Re: Stanley and Rebecca Roberts. Applications to develop Tolovana Park Block 1 Lot 13.

August 6, 2020 ADDENDUM: Response to City Planner August 3, 2020 Letter.

August 6, 2020 ADDENDUM: Response to City Planner August 3, 2020 Letter.

### ADDENDUM DOCUMENTS

C3b

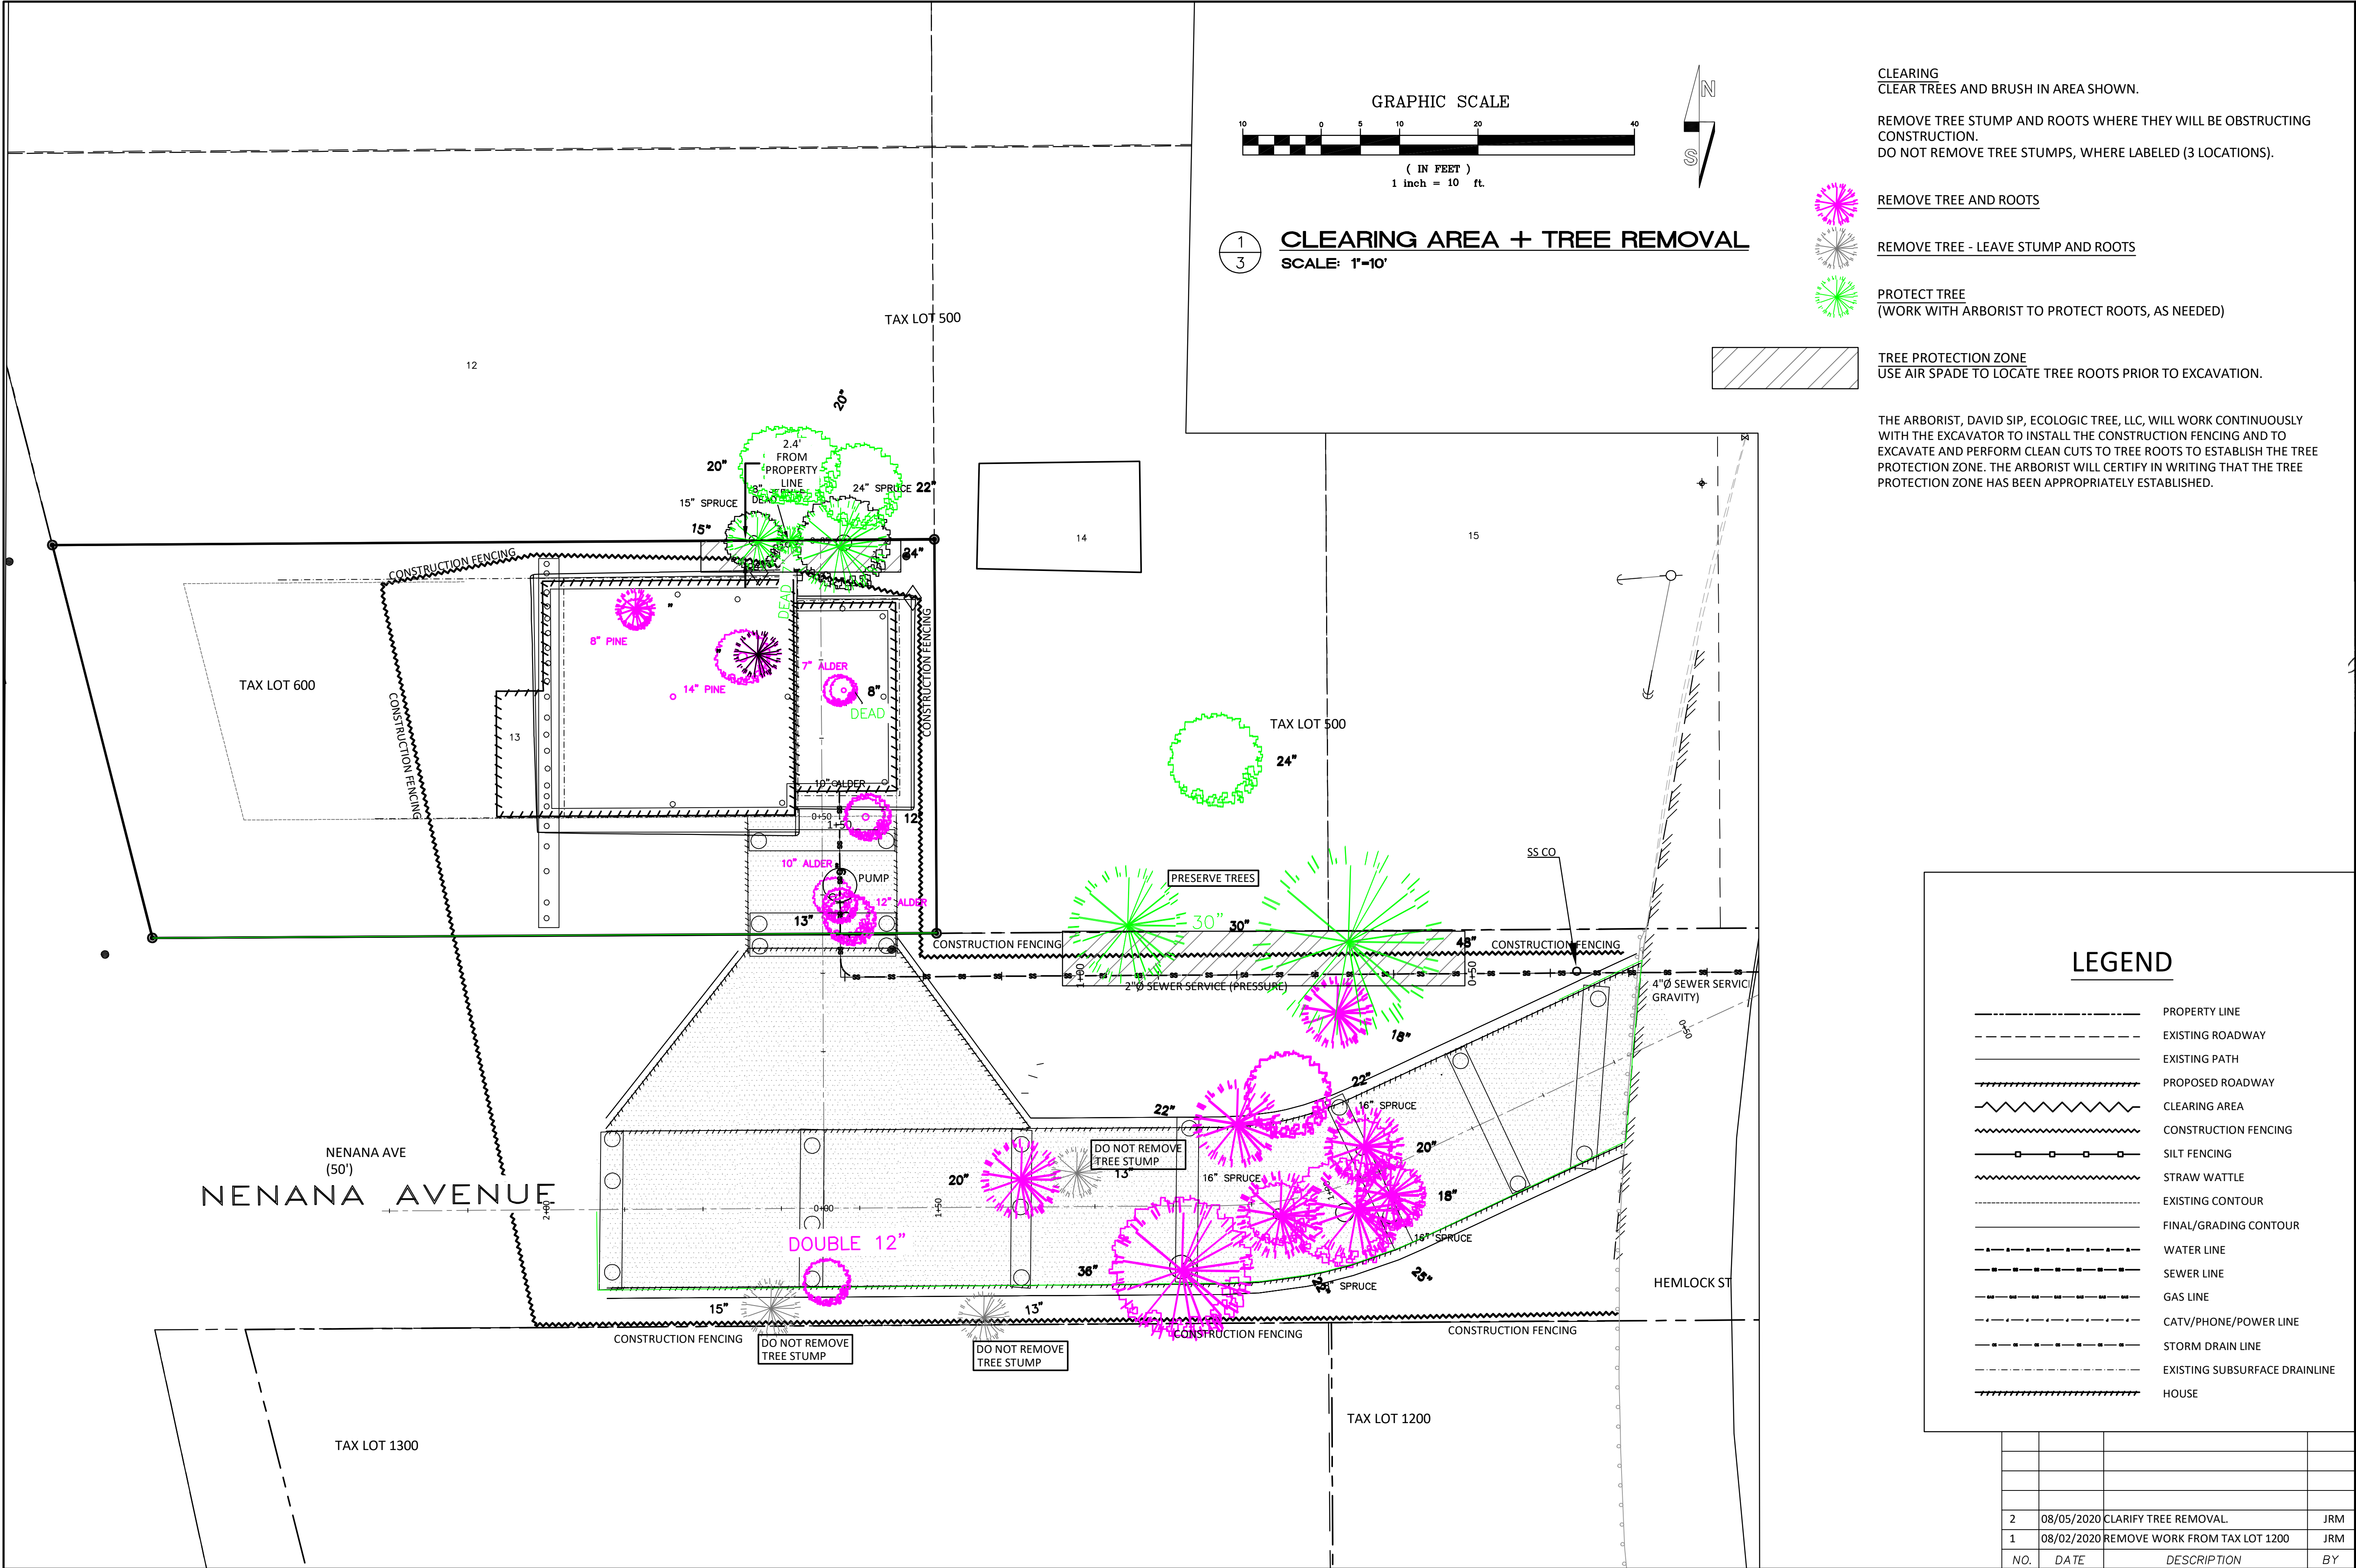
REMOVE TREE STUMP AND ROOTS WHERE THEY WILL BE OBSTRUCTING  
CONSTRUCTION.  
DO NOT REMOVE TREE STUMPS, WHERE LABELED (3 LOCATIONS).

2	08/05/2020	CLARIFY TREE REMOVAL.	JRM
1	08/02/2020	REMOVE WORK FROM TAX LOT 1200	JRM
NO.	DATE	DESCRIPTION	BY

SHEET TITLE:	
SITE PLAN	
REVISIONS:	
DATE:	08/05/20
SCALE:	AS SHOWN
DRAWN:	SMW
CHECKED BY:	JC
JOB NO.:

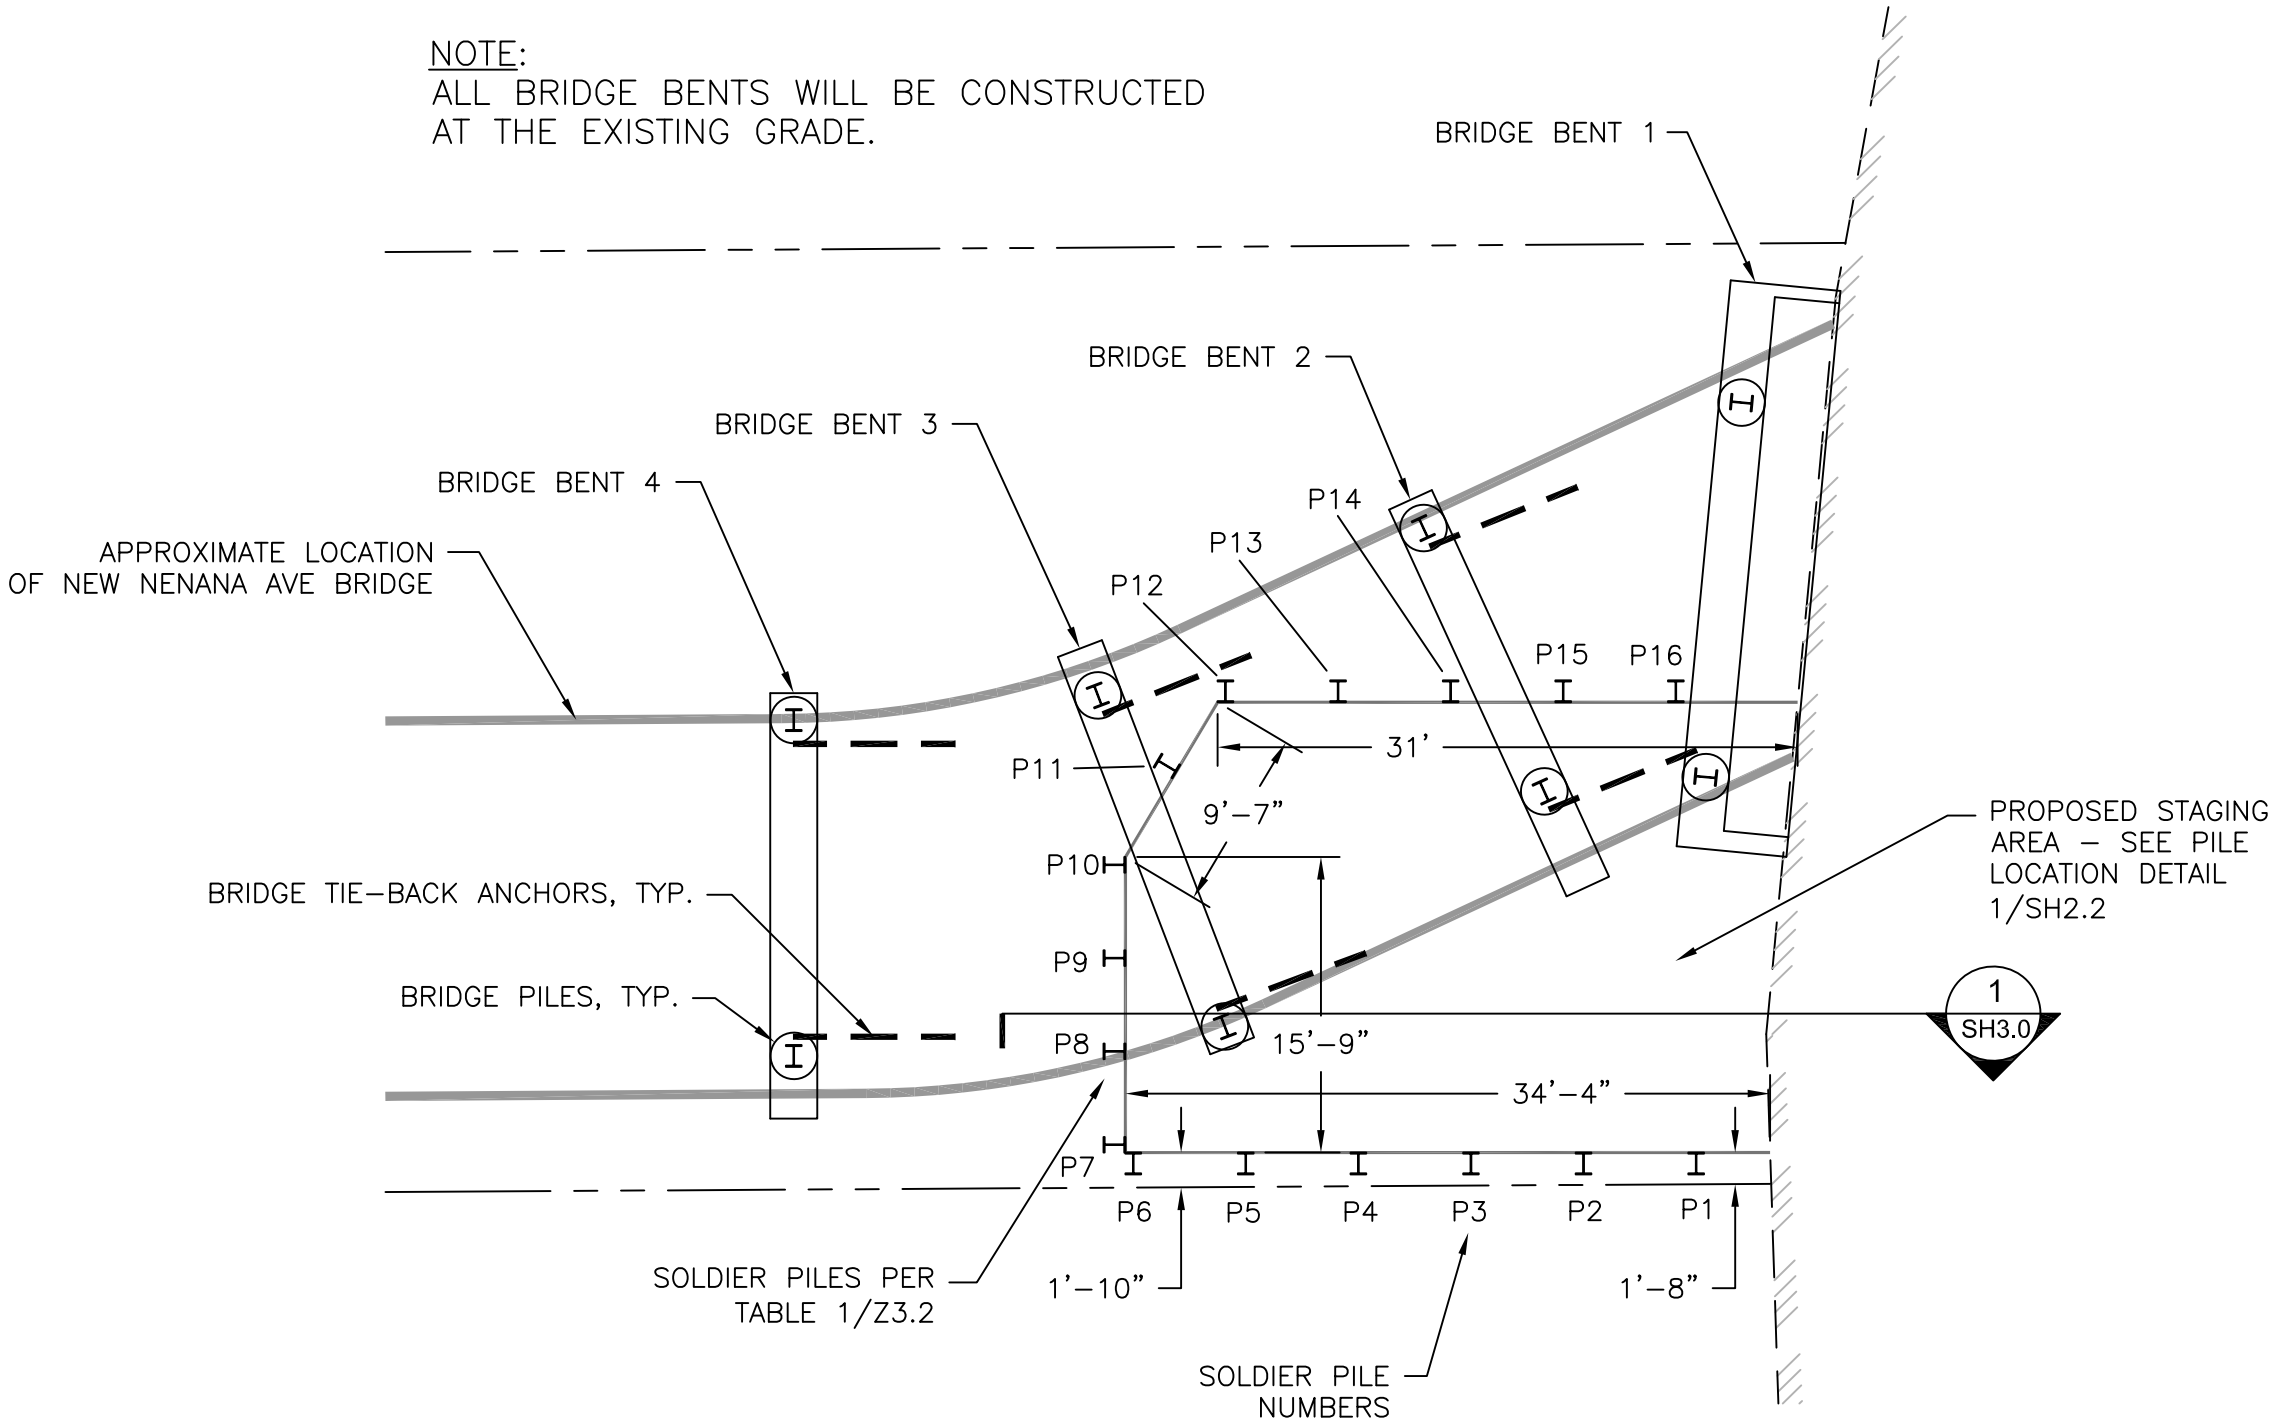
This Nenana Avenue Staging Area Plan replaces the Staging Area previously proposed on Tax Lot 1200.

Figure 1 – Portion of Roberts Staging Area, plan sheet Z2.0 showing Erosion Control Fence.

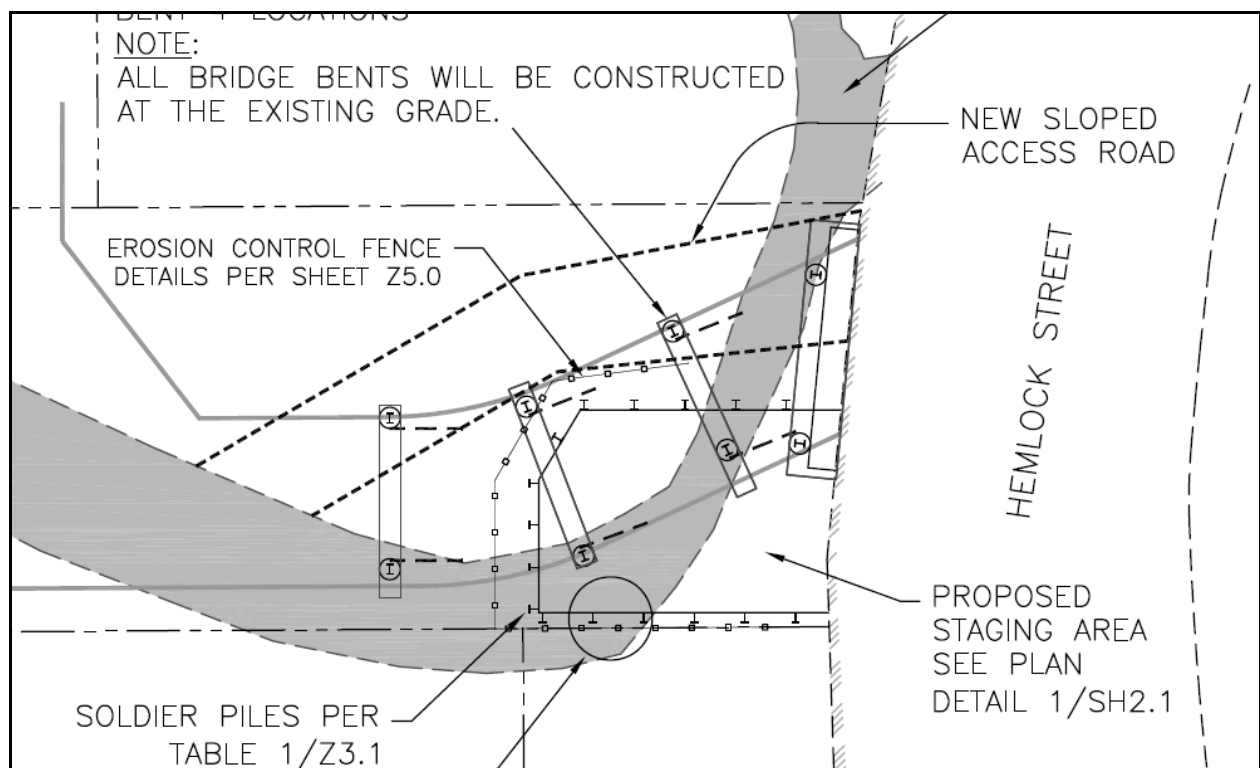
From my engineering geologic perspective, I feel the plans are acceptable and demonstrate appropriate thought and planning to enable the proposed construction to proceed into fall weather, if necessary. As I note in my email communication, I advocate placing erosion control fence as high on the slope as possible to containing drilling spoils and fluids. If this foundation drilling project extends into wet weather it may be necessary to install and maintain multiple layers of erosion control fence below the area of concentrated soldier pile drilling, see Figure 1. The well graded crushed rock access ramp currently in place behind the Hemlock Street guard rail (see Photo 1), in my opinion, can serve as its own erosion control media if it is protected from over washing fines from up slope drilling operations.
